LINCOLN/LANCASTER COUNTY PLANNING COMMISSION STAFF REPORT

APPLICATION NUMBER Change of Zone 05061D	FINAL ACTION? No	DEVELOPER/OWNER Nebraska Horsemen's Benevolent and Protective Association
PLANNING COMMISSION HEARING DATE March 17, 2021	RELATED APPLICATIONS None	PROPERTY ADDRESS/LOCATION S. 1 st Street & W. Denton Road

Change of Zone #: CZ05061D
Southwest Village PUD
S 1st St & W Denton Rd

SITE PLAN
(NORTH OF W. DENTON RD.)

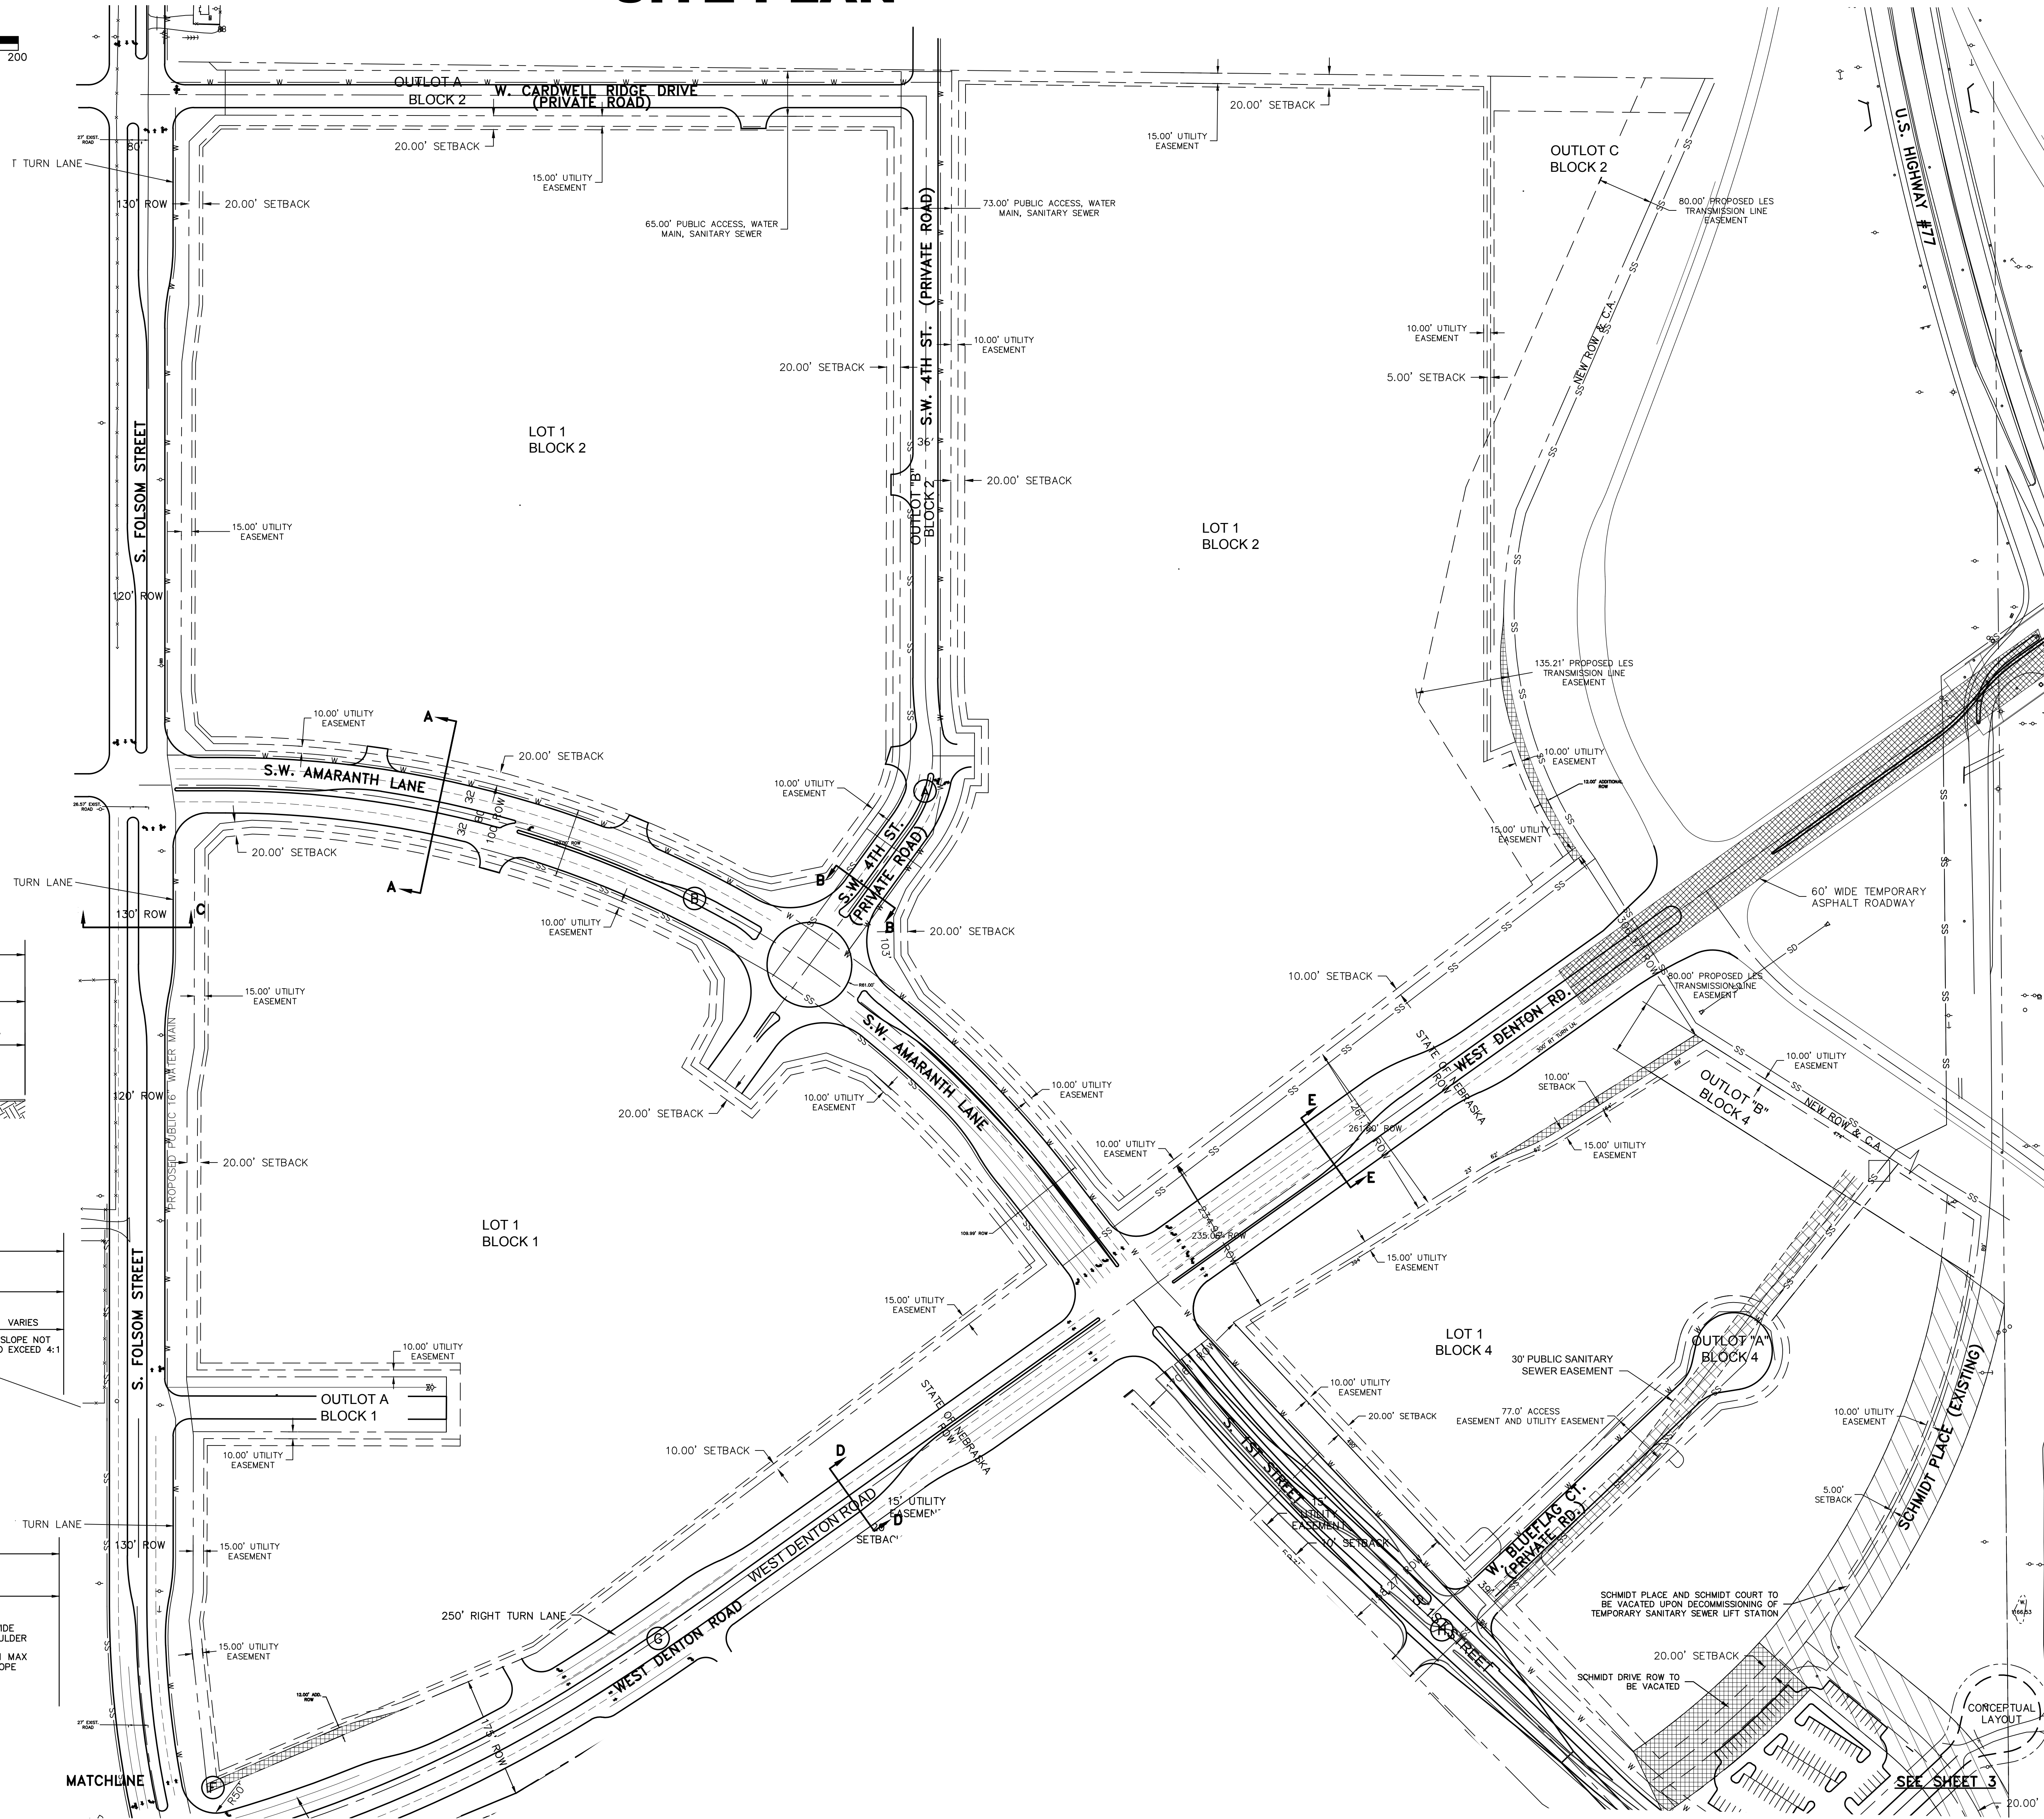
- 2.18 Remove the parking stalls from the access road connection located south of the parking garage.
- 2.19 Prior to receiving building permits, the Southwest Village 3rd Addition final plat must be approved and filed.

- 2.20 In the note on Sheet 3 about pedestrian access, change “analyzed” to “approved” by LTU.
- 2.21 Add more details showing Schmidt Court and existing right-of-way in that area.

- 2.22 Show a street connection at Schmidt Court that connects to the conceptual layout on the east side of S. 1st Street.
- 2.23 On Sheet 3, add a note stating that 1) Schmidt Drive, between South 1st Street and Schmidt Court is to be vacated and removed, and 2) Schmidt Court is to be paved from the roundabout to Schmidt Place with construction of South 1st Street.

- 2.24 Add a label for the future Schmidt Court.
- 2.25 Address the attached comments from Watershed Management.
- 2.26 Revise the Traffic Study to the satisfaction of Lincoln Transportation and Utilities.
